Special Use Permit #2009-0059
516 A East Howell Avenue – Parking Reduction

Application	General Data	
Request: Consideration of a request for a parking reduction and yard modifications for a single family detached home.	Planning Commission Hearing:	February 2, 2010
	City Council Hearing:	February 20, 2010
Address: 516 A East Howell Avenue	Zone:	RB/Residential
Applicant: Douglas Drabkowski	Small Area Plan:	Potomac West

SUP #2009-0059

Photo showing DOMVER utility line location feeding neighbor (514) house. Board against 518 house shows how far back utility is buried on 518A E. Howell

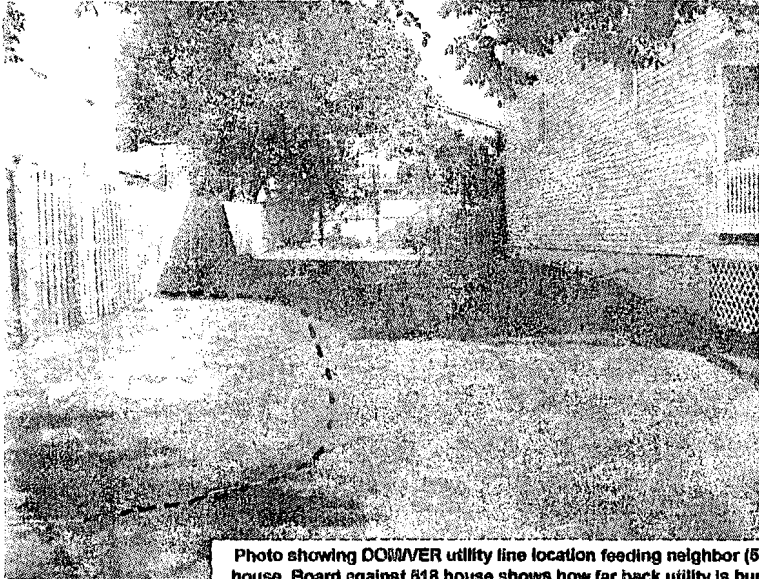
As shown in the attached application material, underground electric lines are located across the front and central portion of the lot toward the west side in a semi-circle shape. Underground gas lines are located on the southeastern corner of the property next to 518 East Howell. Staff has discussed the issue with the applicant on several occasions since these lines must be removed prior to construction. According to the applicant, no utility easements exist on the lot, which is consistent with the survey plat. Staff agrees with the applicant that the utility companies most likely erred in locating the lines, possibly because they took the most straightforward or least expensive solution for connecting service to neighboring properties.

Staff has requested that the applicant contact both utility companies to find out how the lines were placed in their present location, what process must take place in order to move the lines, and who must pay for the cost of moving the lines. As of this writing, the applicant has received a response only from Washington Gas, which informed him that it needed additional information, including a plat, which he provided, before it could give a definitive answer. Washington Gas also told the applicant that if a placement error occurred on the site the lines would be relocated at no cost to any property owner.

Staff agrees with the neighbors' concern about utilities. Although it acknowledges his efforts, staff does not believe the applicant has fully settled the issue. Therefore, staff has included condition language requiring the applicant to report to City staff on a regular basis regarding the process, costs, and who will pay for utility relocation until such time as the issue is resolved.

3. The applicant shall report on a regular basis to Planning & Zoning staff, to the satisfaction of the Director, regarding the process, costs, and responsibility for paying for utility relocation until such time as the issue is resolved. (P&Z)

Photo of rear tree on neighbor's property that provides some crown coverage on 516A E. Howell

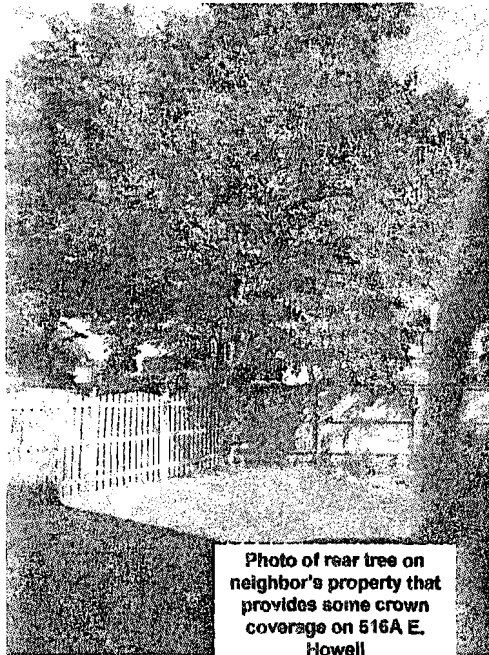
Finally, a question has been raised about how the applicant will meet the 25% tree crown coverage requirement of the Zoning Ordinance. The applicant will be required to meet this requirement by planting one or more trees in his rear yard area consistent with the City's Landscape Guidelines. Sufficient area exists for the applicant to do this. Staff has included condition language requiring a landscape plan to be submitted with the grading plan. Therefore the applicant's specific proposal will be reviewed as a part of that process.

Site Plan Overview
 Scale: 1/8" = 1'-0"

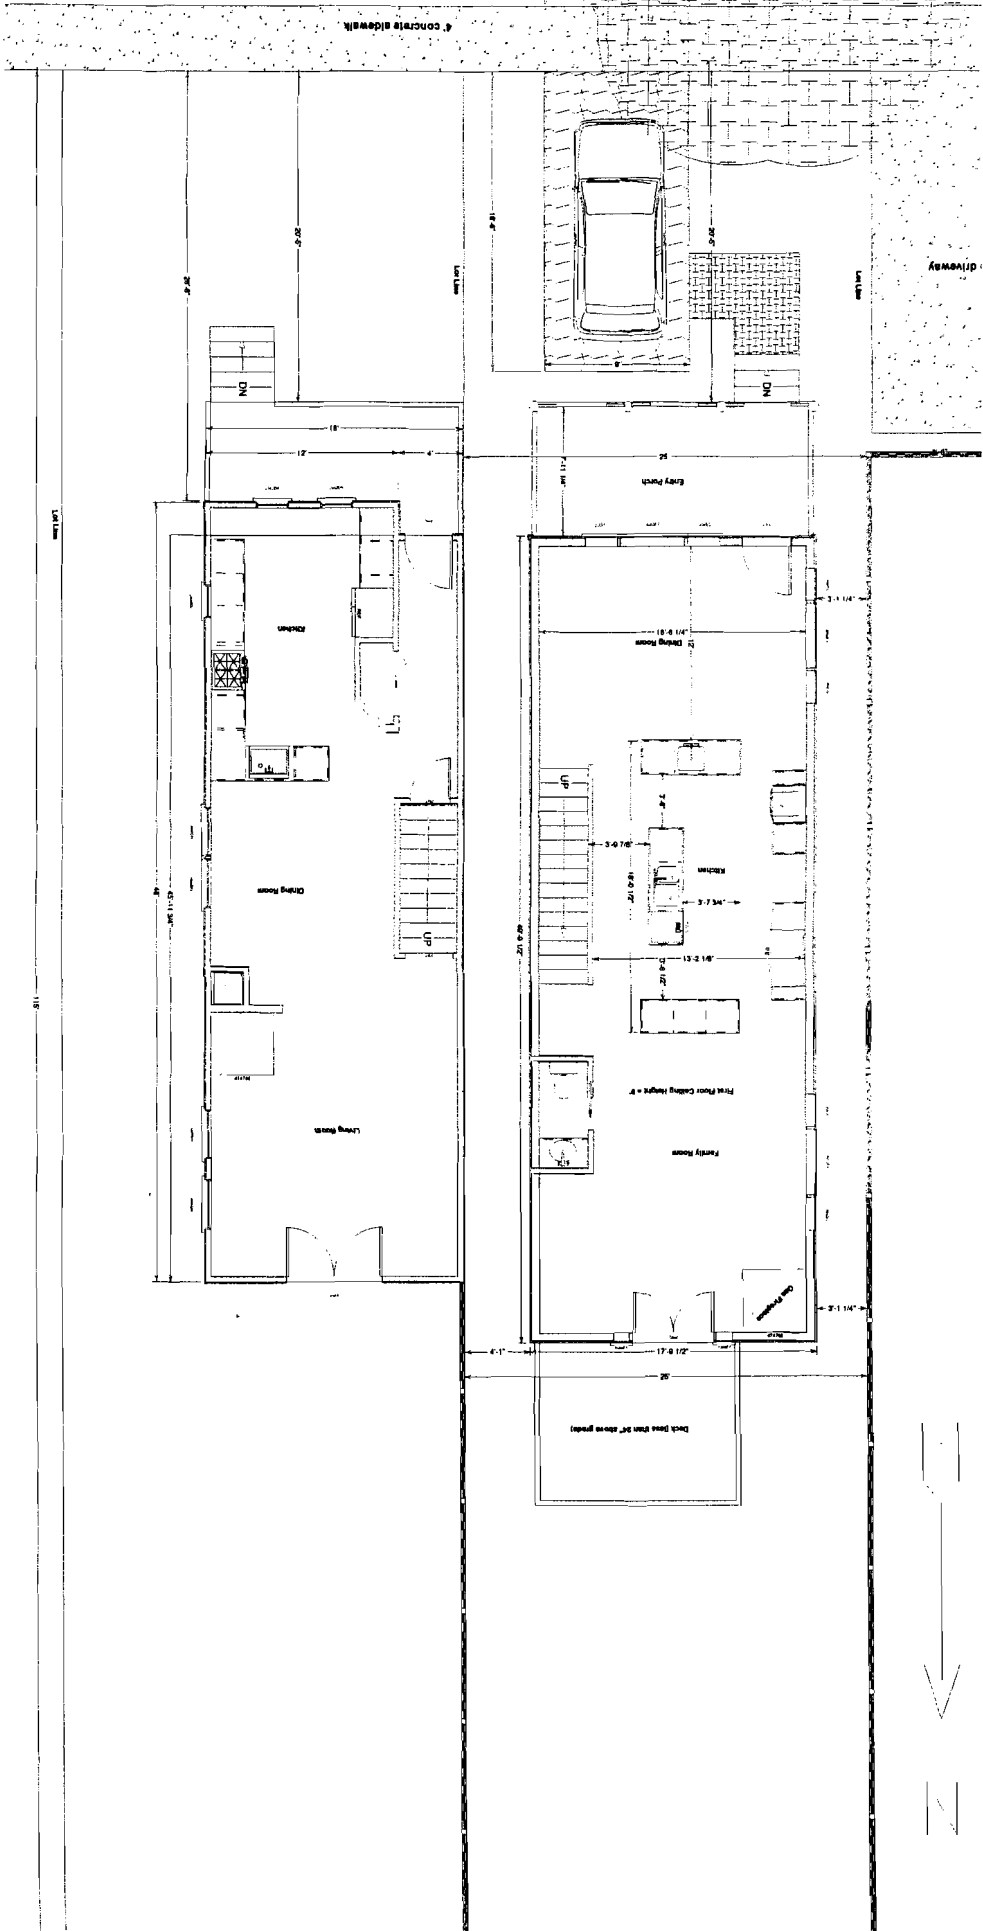
Staff finds that the 27.35-foot average front yard setback required by the infill regulations is not entirely appropriate for this specific property since it would require the new dwelling to be setback farther from the street than either of the two neighboring structures. Staff therefore recommends a modification of the front yard requirement from 27.35 to 20.42 feet in order to match the house next-door at 518 East Howell. The applicant has incorporated this recommendation into his design.

With regard to side yards, some modification seems reasonable in order to build a single-family dwelling on this 25-foot wide lot. At the proposed height, which is average for the immediate area, the applicant could only construct a 6-foot wide house if meeting the required 9.5-foot side yard setbacks requirements. Staff acknowledges that the proposed 3.1-foot and 4.1-foot side yards are small, although because of the existing driveway at neighboring 516 E. Howell, there will be more separation between dwellings on the west side.

The applicant could make the house narrower in order to create larger side yards and decrease the degree of the requested modification. While narrowing the house and adding a foot or so of setback to either side is possible, this would not result in significantly more useable side yards or a perceptibly different separation between the houses. Creating a more meaningful space in the side yards would require a minimum of six feet on each side, which would still result in side yards of somewhat limited use and a house measuring 13 feet wide. Eight-foot side yards would be more fully functional and would count toward open space requirements, but this would result in a house measuring nine feet wide. The applicant's request to build a 17.8-foot wide house seems reasonable and is not considerably wider than the house next-door at 518 East Howell, which was approved to be 16 feet wide and was built 15.5 feet wide.

1. **CONDITION AMENDED BY PLANNING COMMISSION:** The single-family dwelling shall be consistent with the design and placement as shown in illustrations and documents dated January 4, 2010 to the satisfaction of the Director of Planning & Zoning except that the dwelling shall measure 16.8 feet wide instead of 17.8 and the dwelling shall be moved one foot to the east, resulting in a west side setback of 5.1 feet and an east side setback of 3.1 feet. (PC) (P&Z)

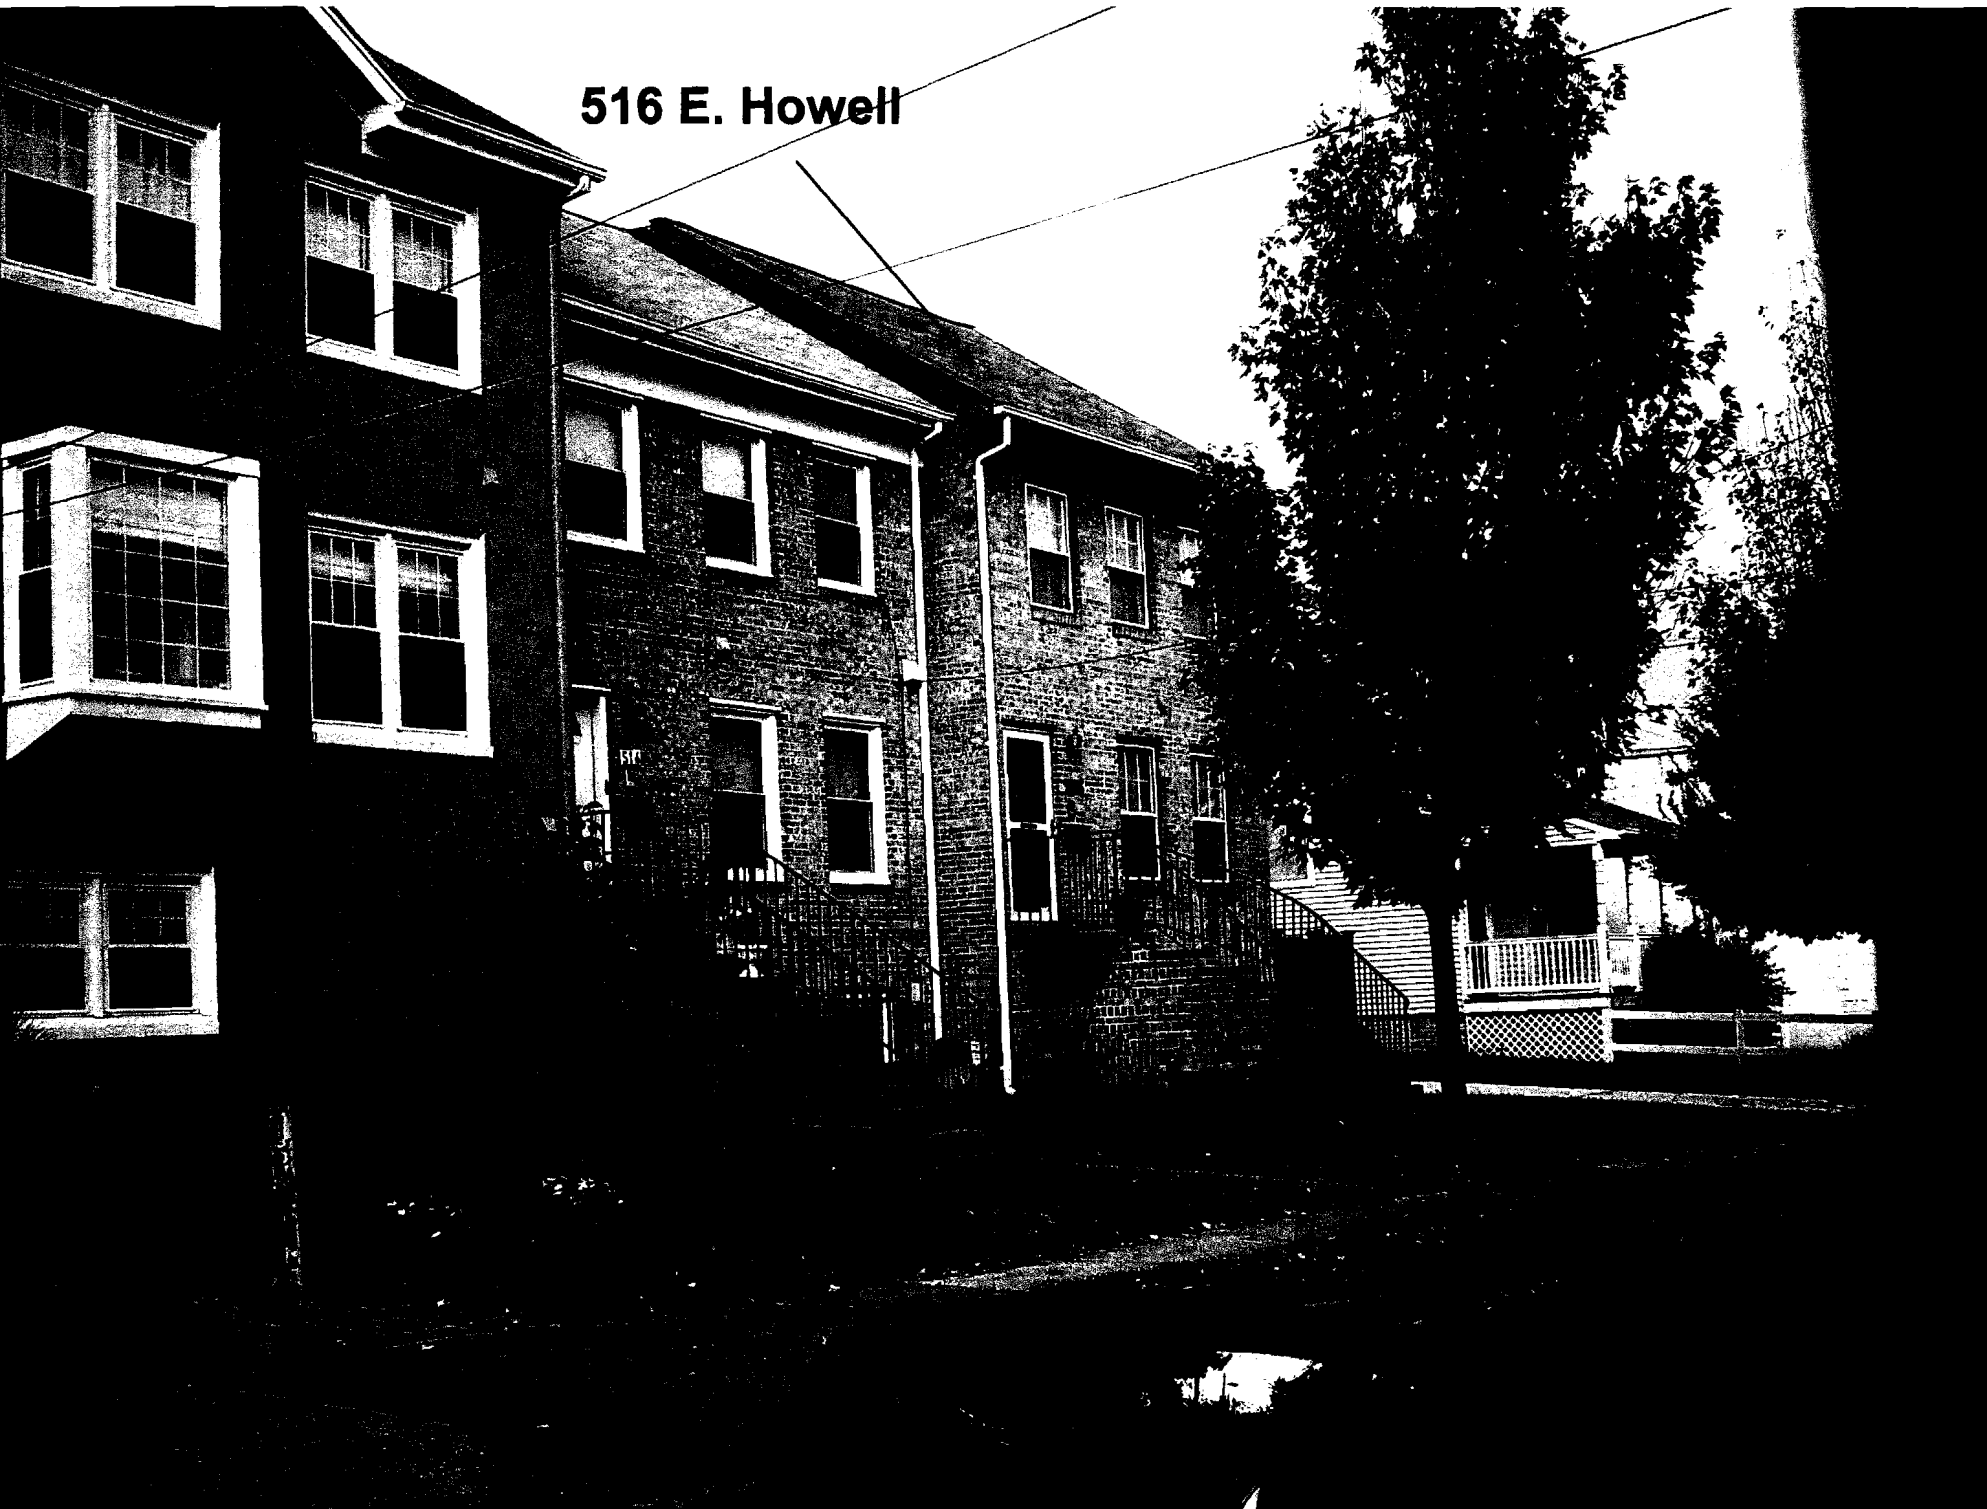
Regarding the width of the Applicant’s home, he is being denied the opportunity for a standard side yard and the corresponding open space, due to the two factors noted previously. He has the right to maximize the value of his home, and the only way for him to do so is by increasing its footprint. The walls of the Applicant’s home are 6” steel studs, which reduces the finished living space by 2” around the entire perimeter of the house, when compared to the 2x4 walls at 518 E. Howell. As demonstrated in the slides, a two-foot difference in the distance between 516 E. Howell and 516A E. Howell provides no noticeable increase in view.

More importantly, reducing the space between 516A E. Howell and 518 E. Howell to just 37” introduces significant access and safety problems. Per OSHA guidelines, the bottom of a ladder should be placed ¼ of its working length away from the structure—a 3’ space would limit the ladder length to just 12’, making it almost impossible to perform routine maintenance and repairs

on either house (both structures are more than 30' high). Standard scaffolding comes in 3', 4', or 5' widths, and specialty scaffolding will be very difficult to erect and maneuver in such a confined space. A distance of only 37" literally prevents the use of a hammer, spray painting equipment or pressure washers. Finally, while the Applicant's home will have a 2-hour fire-rated wall, the house at 518 E. Howell is 2x4 wood construction with vinyl siding—in the event of a fire, emergency response personnel will have a very difficult time in gaining access to 518 E. Howell with firefighting equipment.

3D Rendering showing actual separation between the houses @ 516, 516A, & 518 E. Howell

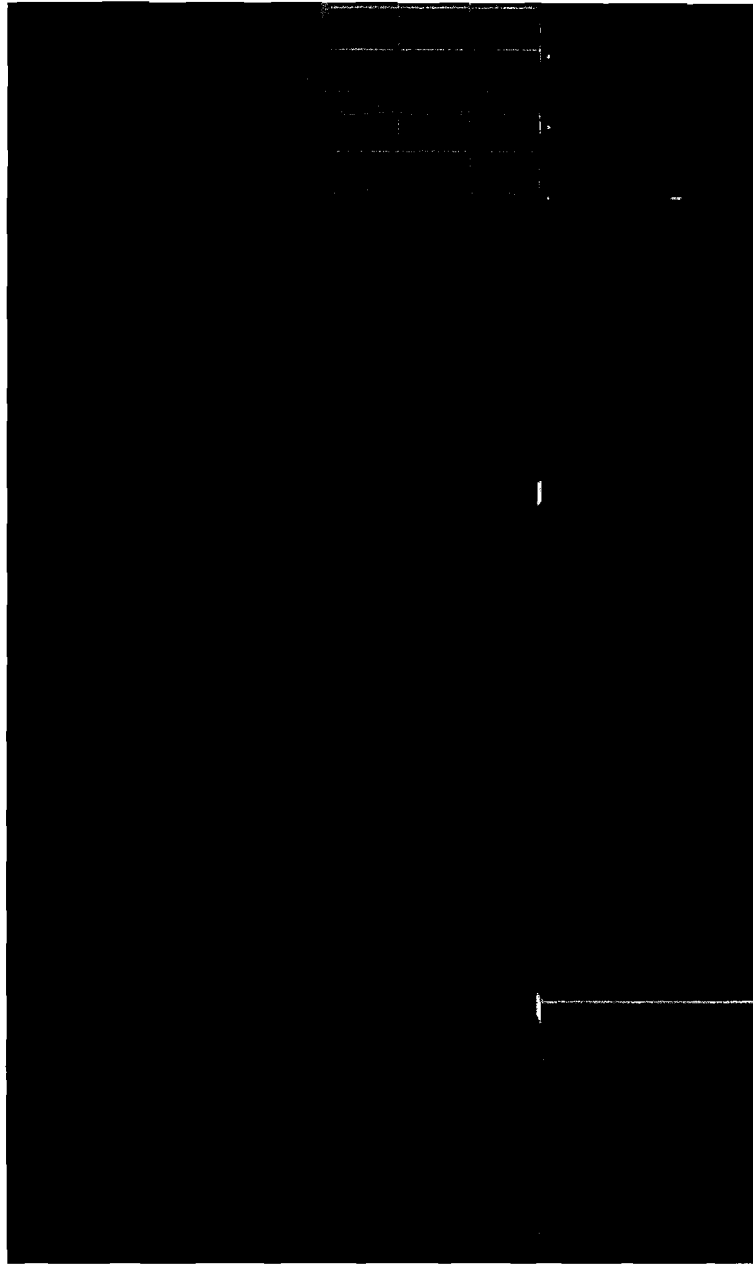
My neighbor at 516 has expressed concern over the impact on his view and quality of life if I am allowed to proceed as planned and approved by the P&Z Staff. The Planning Commission vote on 2FEB10 would require shifting my home one foot to the right (towards 518 E. Howell), and shrink the width of my home by at least one foot. These two actions would increase the distance between 516 E. Howell and 516A E. Howell by two feet (to 61"), but it would *decrease* the distance between 516A E. Howell and 518 E. Howell by one foot (to only 37"). The neighbor request puts an unreasonable restraint on me for what I should be allowed to build on my property. The total distance between 516 and 516a as planned is 11 feet, with the neighbor requesting me to make it 13 feet, it will remove 200 sq ft of living space in my house, and requires a redesign of the floor plan and impacts the floor plan functionality. As such I request that the 3'1 inch set back from the property of 516 be retained. .

The owner of 516 E. Howell has expressed concern over the impact on his view and quality of life if the Applicant is allowed to proceed as planned and approved by the P&Z Staff. The Planning Commission vote on 2FEB10 would require the Applicant to shift his home one foot to the right (towards 518 E. Howell), and shrink the width of his home by at least one foot. These two actions would increase the distance between 516 E. Howell and 516A E. Howell by two feet (to 61”), but it would *decrease* the distance between 516A E. Howell and 518 E. Howell by one foot (to only 37”).
